REMARKS

This Supplemental Response addresses the issues set forth in the Office Action dated March 16, 2004, as well as issues set forth in the Advisory Action dated September 28, 2004. Applicants are especially grateful for the careful consideration that Examiner Ciric has given to this application and for the helpful suggestions made for improving the application text and claims. The Examiner apparently appreciates the challenges in defining the present invention, which involves the somewhat unusual situation involving selectively and alternatively attachable parts. Applicants appreciate the helpful and cooperative spirit in which this application has been considered.

Amendments to the Drawings:

Fig. 1

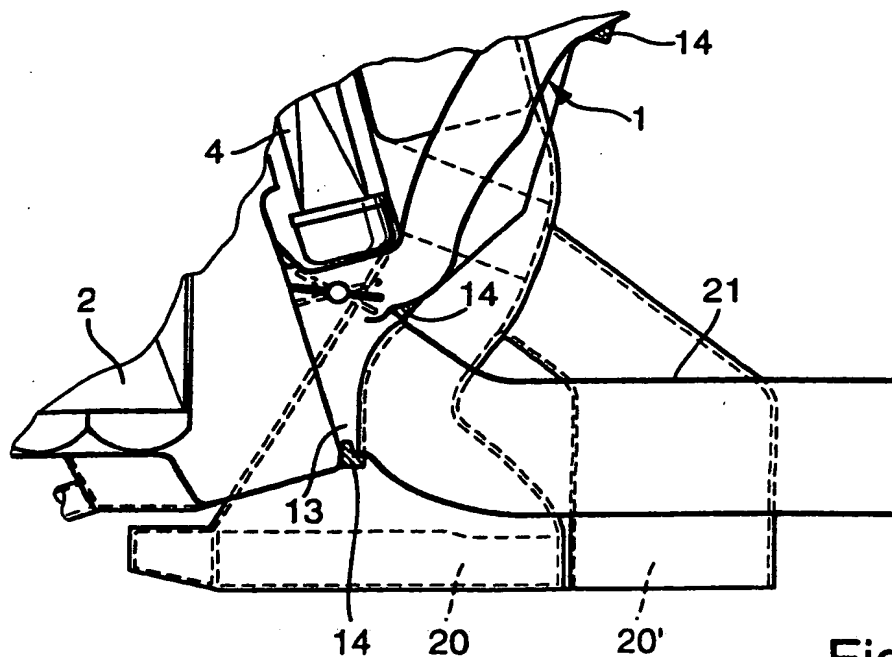
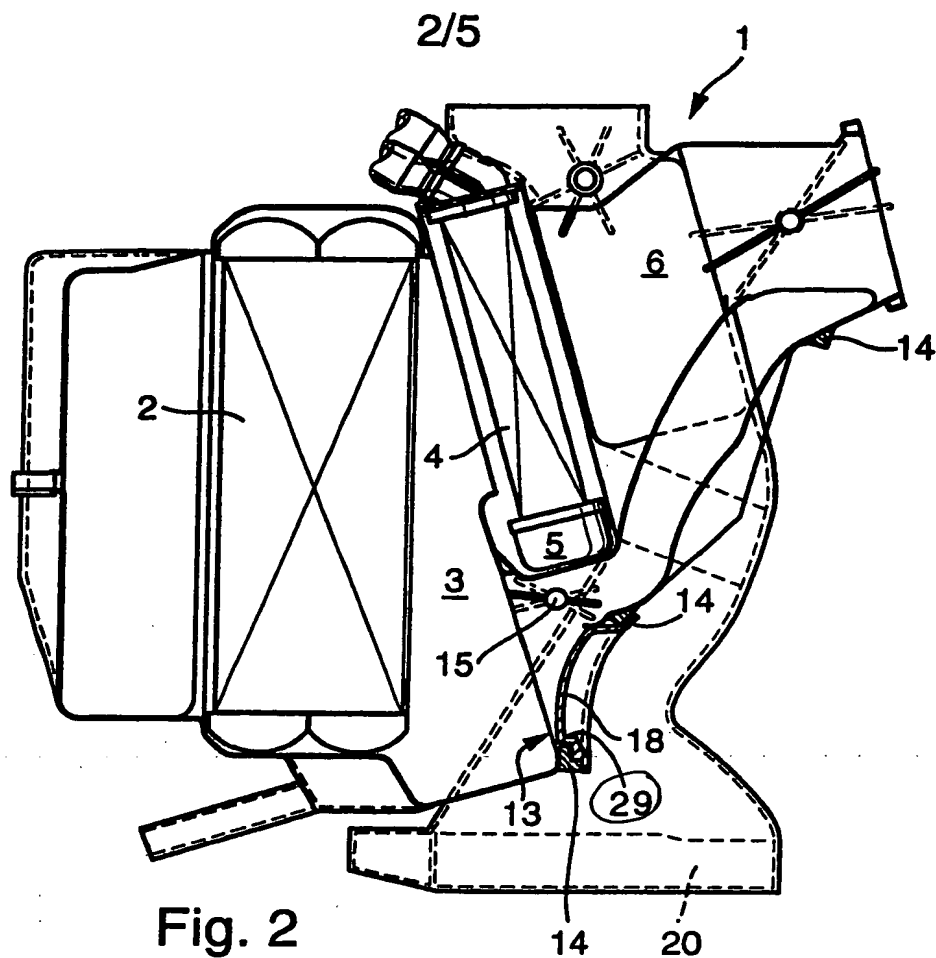
As noted above, Figures 1, 2 and 4 have been amended to identify more clearly the corresponding portions of the connection section and of the respective cover 18 and additional housing 10 of the rear temperature control unit. Similarly, Figure 1 now depicts the PTC units in heater 4. Approval of these proposed changes is respectfully requested.

The drawing sheets attached in connection with the above-identified application contain Figures 1-4 are being presented as corrected drawing sheets to be substituted for the previously submitted drawing sheets. Also attached is a replacement formal drawing sheet for Figure 7, which was approved in the Office Action. Drawing Figures 1, 2 and 4 have been amended. The specific changes which have been made to Figure 1 are a schematic depiction of a PTC heating element and reference numerals 31 referring to the portions of the connecting structure formed on the additional housing 10 that serve as part of means for connecting that housing to the connecting section of the conditioning housing 1. The change to Figure 2 is the addition of new reference numeral 29 to refer to the portion of the connecting structure that is part of cover 18 and cooperates with flanges 14 of the connecting section. The change to Figure 4 is the addition of reference numeral 31, similar to Figure 1. Corresponding additions have been made to the specification, above.

Fig. 4

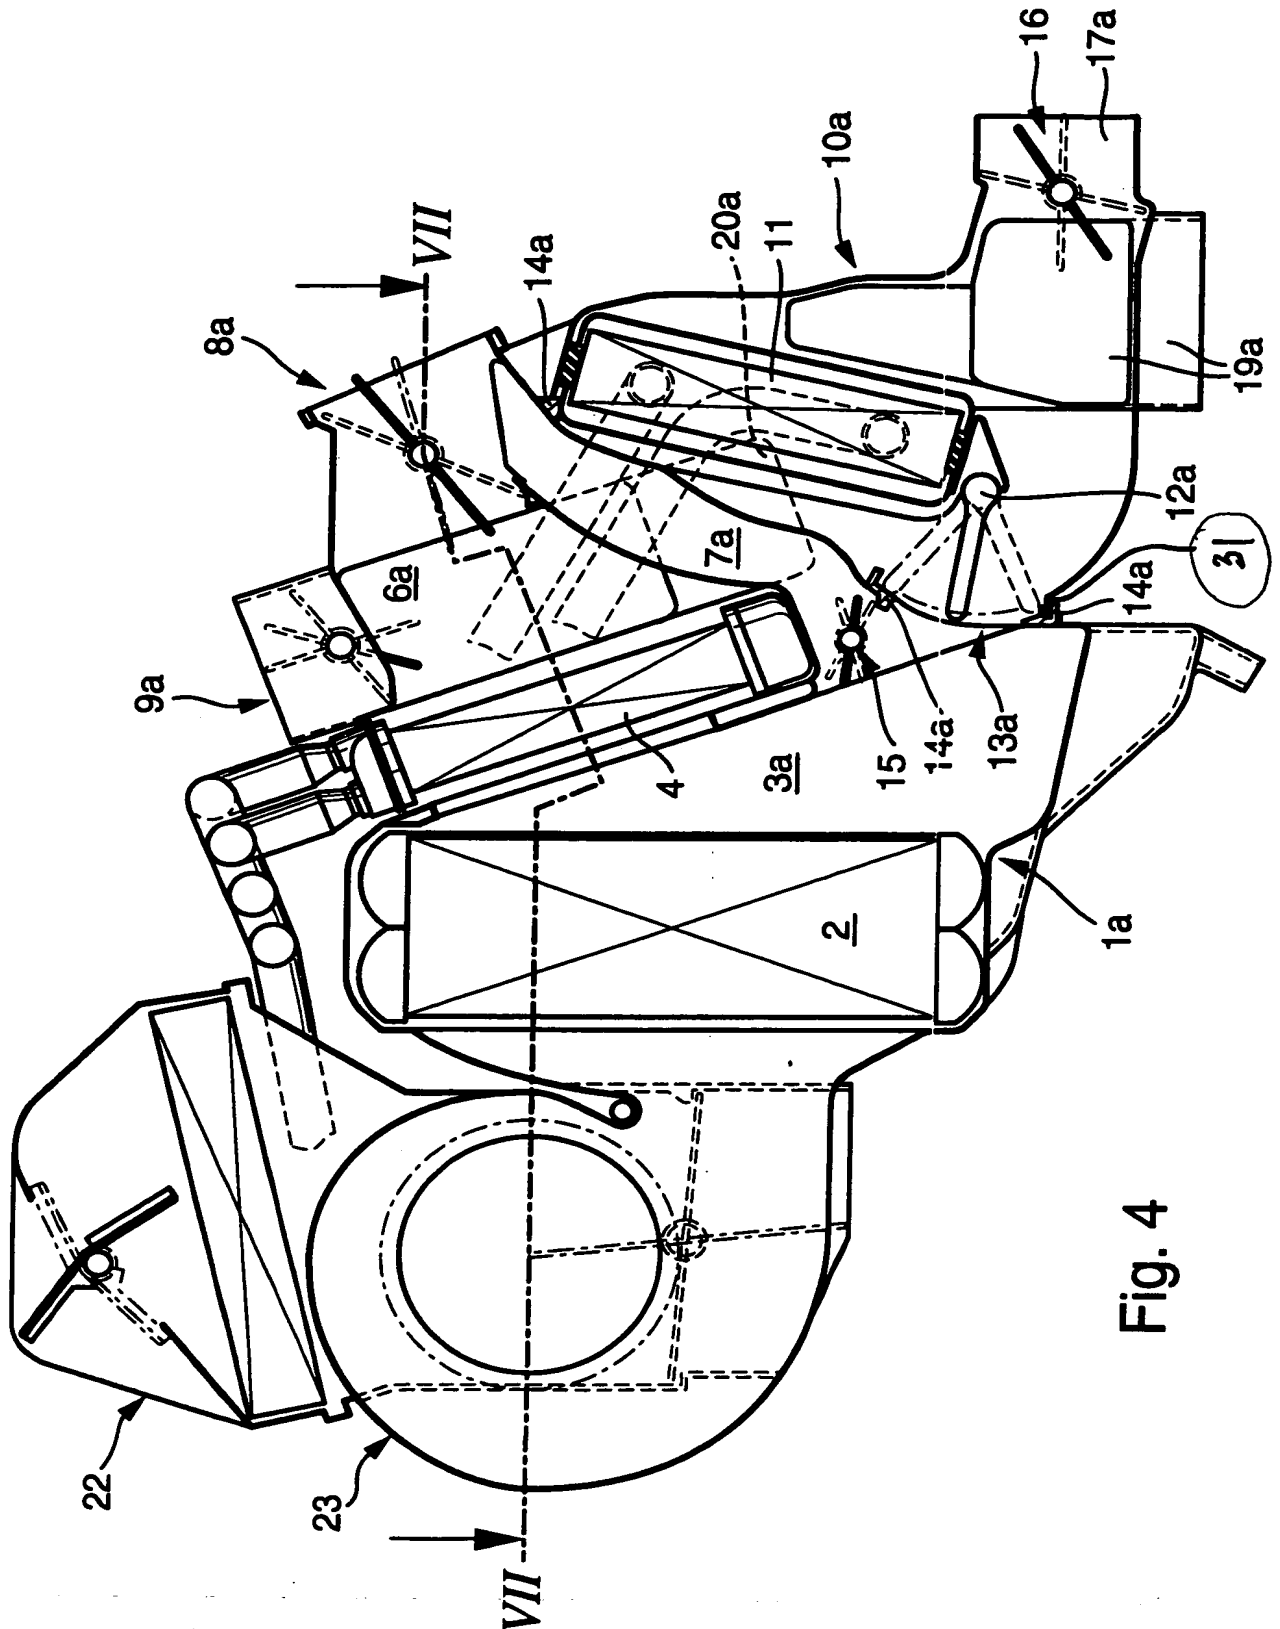
Annotated Marked-up Drawings
